## **HNHS – Restroom Renovation**

**Project #** 2023.0015

### **ADDENDUM NO. A-3**

## ADDENDUM 3 / EXHIBIT 1

P1.8

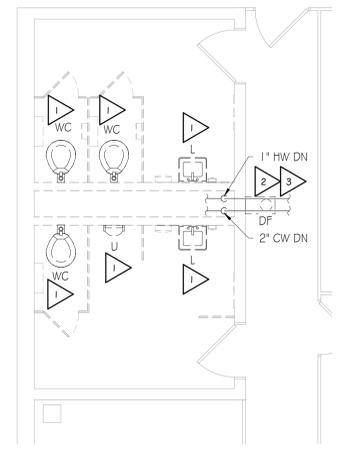
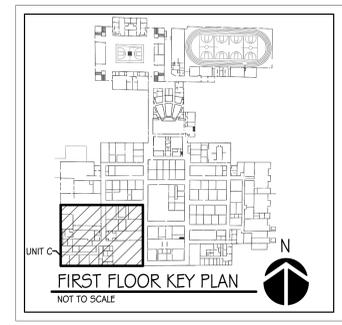
**Item:** A-3.15  
**Location:** Drawing Sheet P1.8  
**Description:** **Revision:** Revise the First Floor Plumbing Plan – Unit C – Admin. Office Staff Toilet C105 fixtures tags as shown on the attached **EXHIBIT 1**.
